UNITED STATES PATENT AND TRADEMARK OFFICE

10/526,989

| Office Action Summary | Application No. 10/526,989 | Applicant(s) ZAUNER ET AL. | |

Claim Rejections - 35 USC § 112

[Drawing 3]

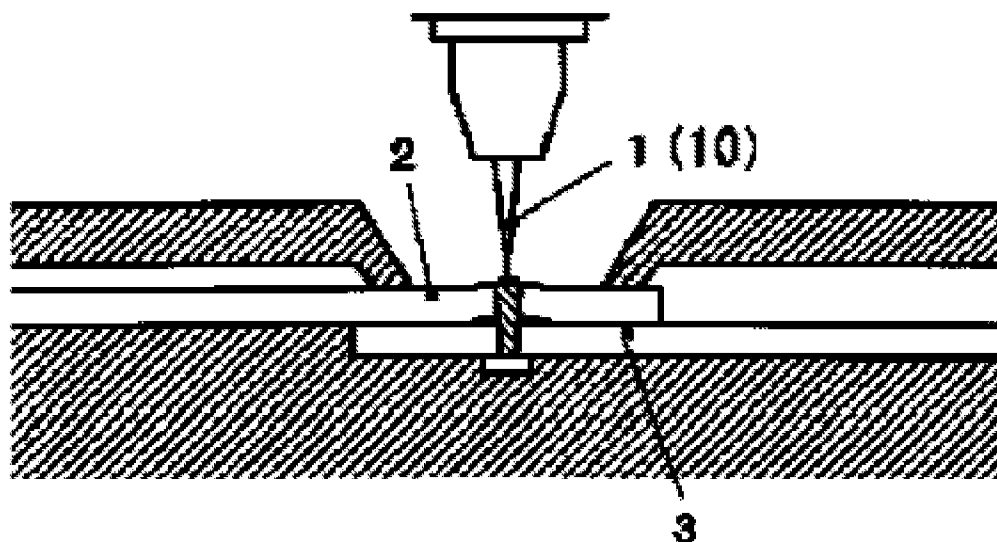
Regarding Claim 5, Fujimoto et al teaches a protrusion on the side facing the laser and the side facing away from the laser as shown in drawing 3.
